Service Bulletin

POOR AUXILLIARY (AUX) JACK SOUND

2010 RX-8 with accessory satellite radio (NOT factory installed)

Bulletin No: 09-030/10	Last Issued: 06/16/2010
© 2010 Mazda Motor of America, Inc.

Connector 0920-201 (Audio Unit/Audio Unit Illumination)

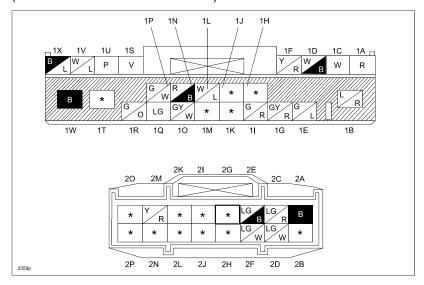
Some vehicles with the accessory satellite radio might experience poor sound from the auxilliary jack. This is caused by a poor ground. To fix the problem, a signal ground wire will be added to an unpopulated cavity, providing a ground path for the accessory harness. This will be done using a 70 mm terminal ended wire placed into terminal 2G of connector 0920-201 (Audio Unit/Audio Unit Illumination), and connected to either LG/W ground wire (terminal 2F or 2D) of the same connector with an IDC.

70 mm terminal ended wire with IDC

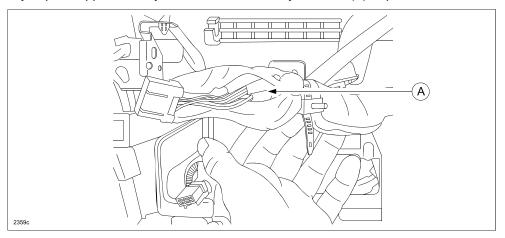
7. Very carefully expose approximately 2 inches of the factory harness (A) to provide room for the repair.

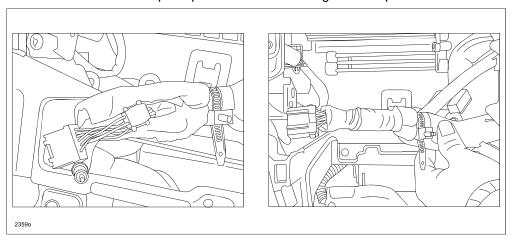
11. Close the harness with electrical tape to prevent rattle or damage to the updated harness.
